Re: Northern Beaches Local Planning Panel (NBLPP) Meeting 7 September 2022

ITEM 4.1 DA2021/1039 - 16 WYATT AVENUE, BELROSE - DEMOLITION WORKS AND THE
CONSTRUCTION OF A BOARDING HOUSE DEVELOPMENT

ITEM 4.2 MOD2021/0996 - 14 WYATT AVENUE, BELROSE - MODIFICATION OF DEVELOPMENT
CONSENT DA2018/0401 GRANTED FOR THE ERECTION OF A PART TWO AND PART
THREE STOREY BOARDING HOUSE.

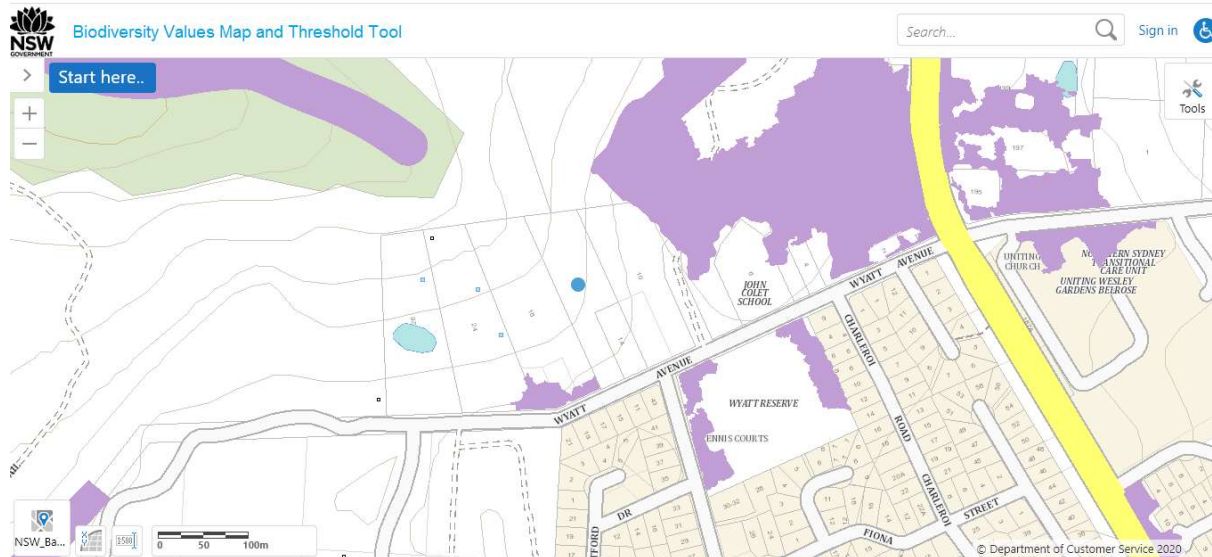
The recently released Northern Beaches Environment/Conservation Zones Review does not show the subject land to have high ecological value.

16 Wyatt Avenue, Belrose.
DA2021/1039

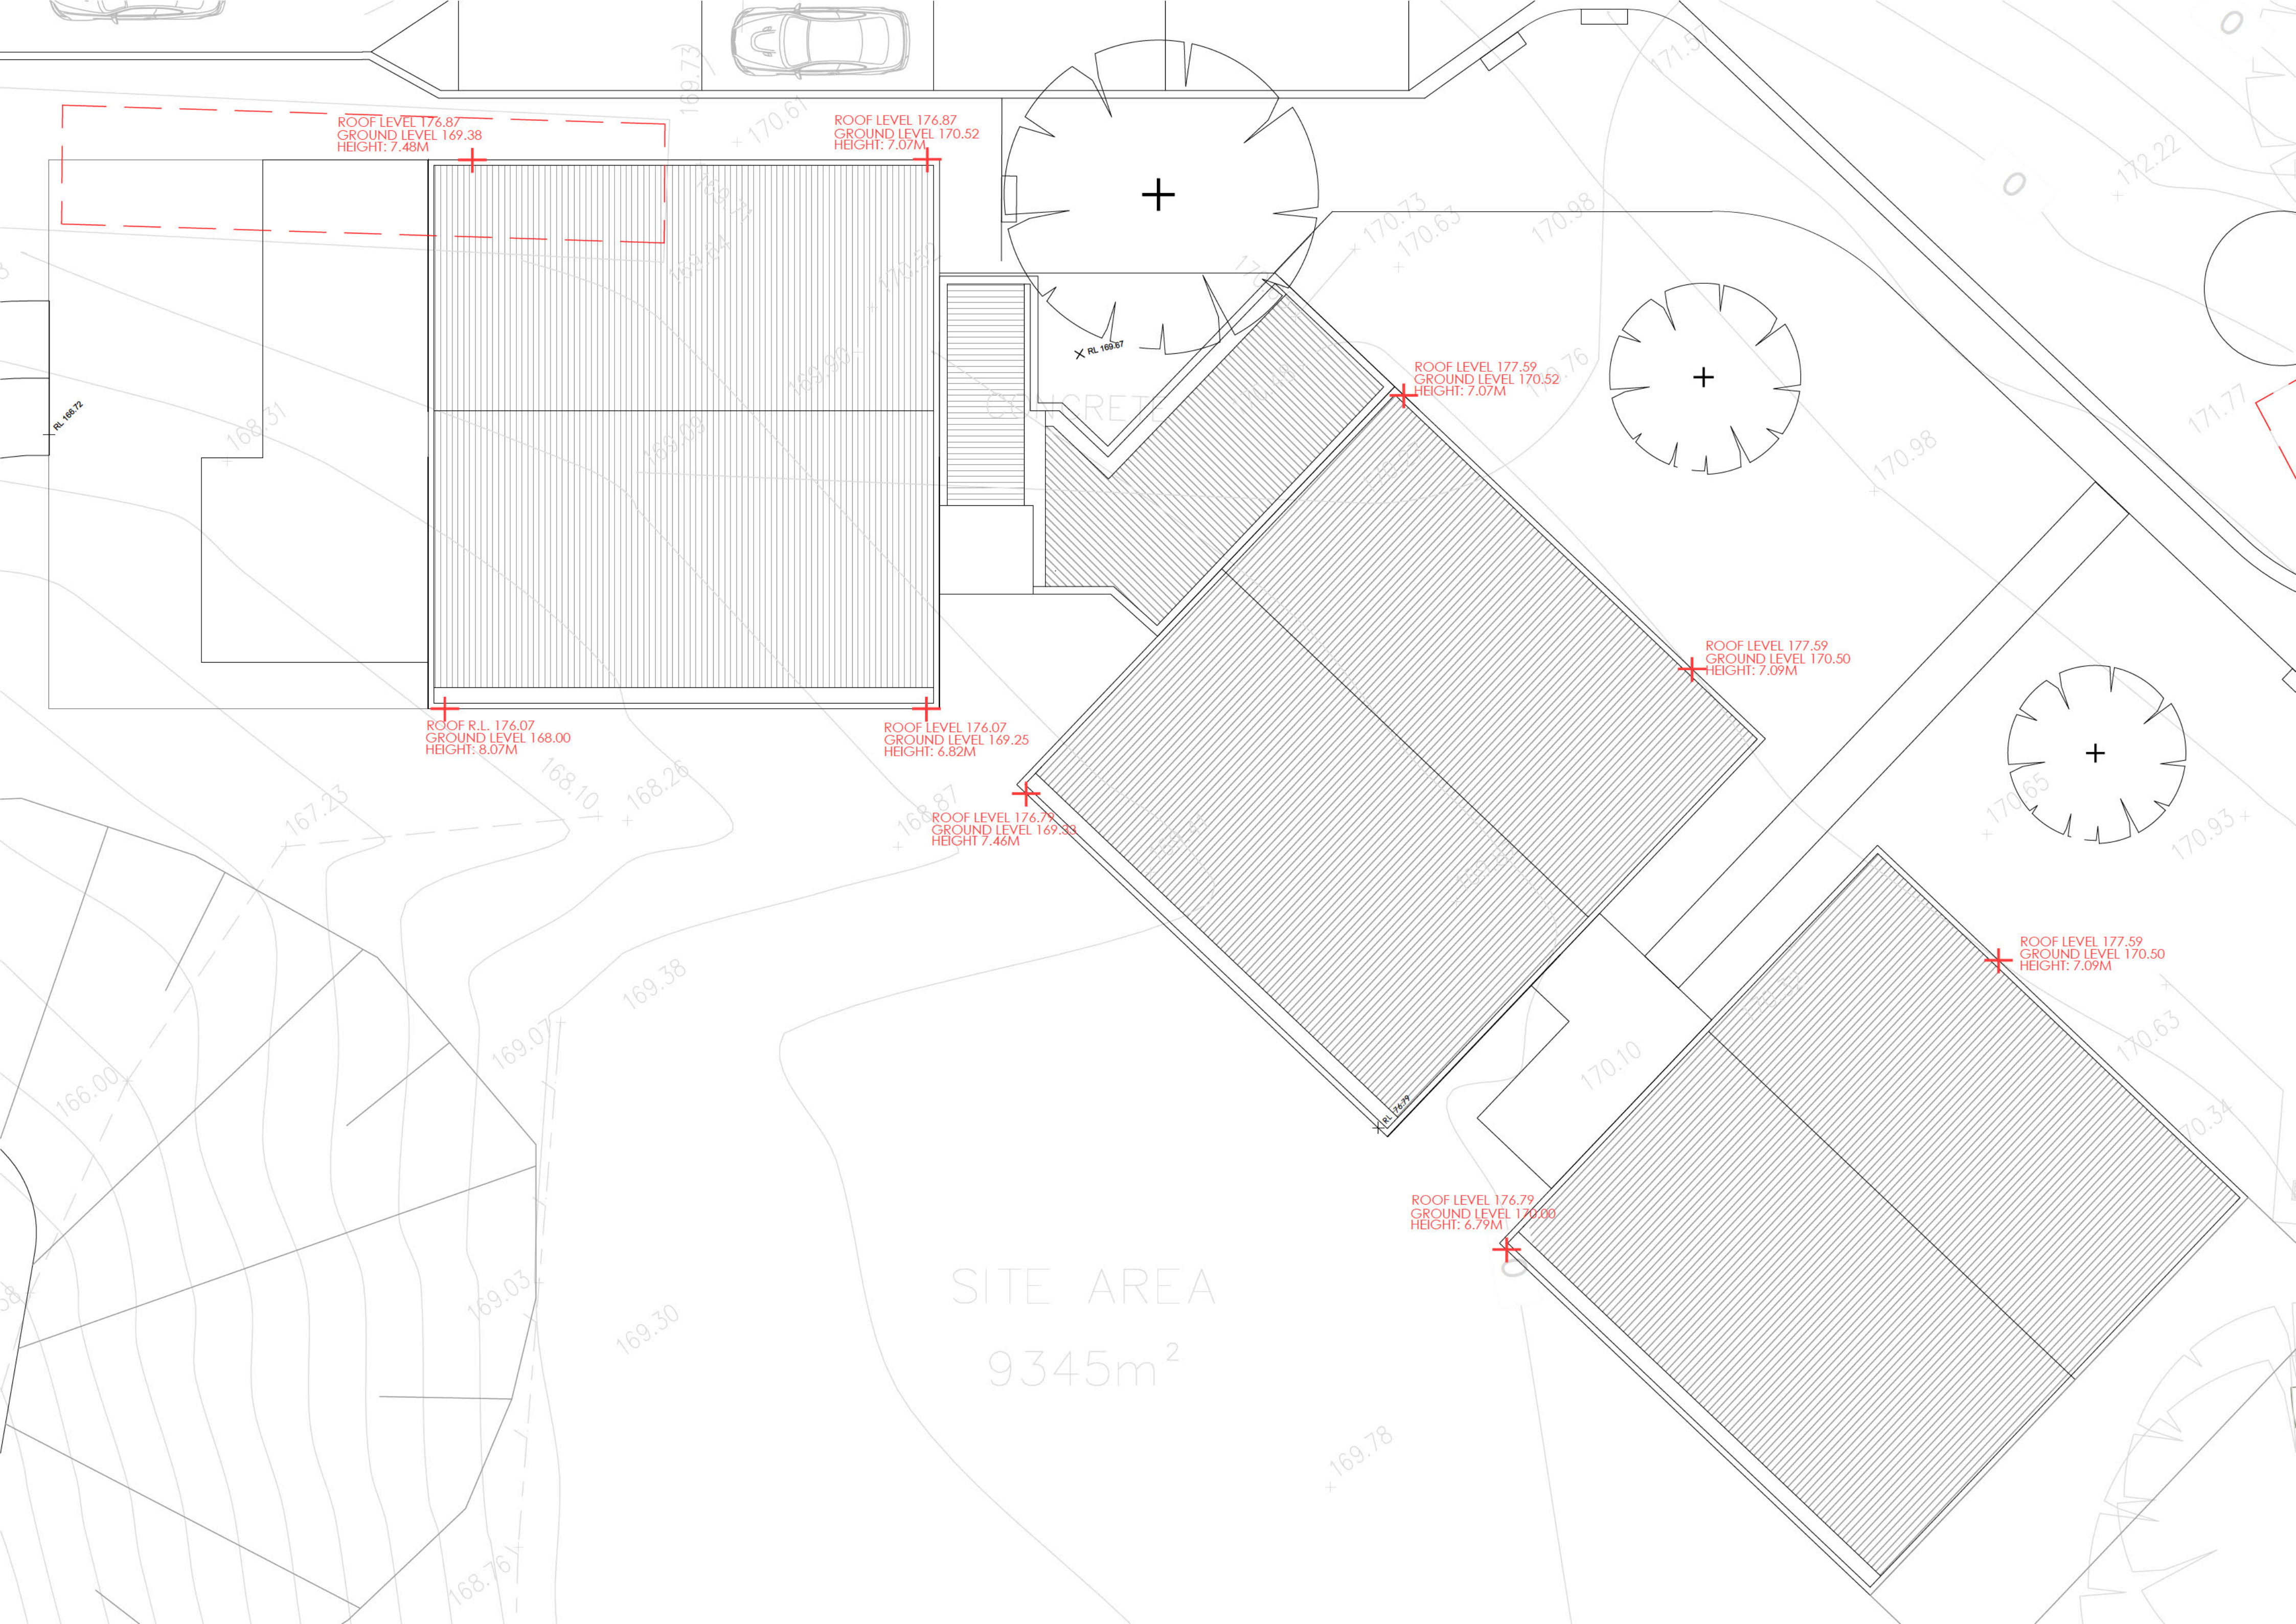
Page 7 – Bullet 1: *The lower building's exceedance of the maximum 8.5 metre building height development standard of the C8 Belrose North Locality of the Warringah Local Environmental Plan 2000.*

The lower building does not exceed the maximum 8.5 metre building height. Appendix B contains a letter and drawing from Platform Architects attesting to this fact.

This letter is to clarify Councils commentary in their recommendation to the Northern Beaches Planning Panel around the overall height of the lower building of the subject Development Application. We attached to this letter, a mark up of the lower building roof plan, overlaid onto the site survey which clearly demonstrates the maximum ridge R.L. in comparison to the existing contour levels.

This confirms the building sits below the 8.5m Height Control.

ROOF LEVEL 176.87
GROUND LEVEL 169.38
HEIGHT: 7.48M

ROOF LEVEL 176.87
GROUND LEVEL 170.52
HEIGHT: 7.07M

ROOF R.L. 176.07
GROUND LEVEL 168.00
HEIGHT: 8.07M

ROOF LEVEL 176.07
GROUND LEVEL 169.25
HEIGHT: 6.82M

ROOF LEVEL 176.79
GROUND LEVEL 169.33
HEIGHT: 7.46M

ROOF LEVEL 177.59
GROUND LEVEL 170.52
HEIGHT: 7.07M

ROOF LEVEL 177.59
GROUND LEVEL 170.50
HEIGHT: 7.09M

ROOF LEVEL 177.59
GROUND LEVEL 170.50
HEIGHT: 7.09M

ROOF LEVEL 176.79
GROUND LEVEL 170.00
HEIGHT: 6.79M
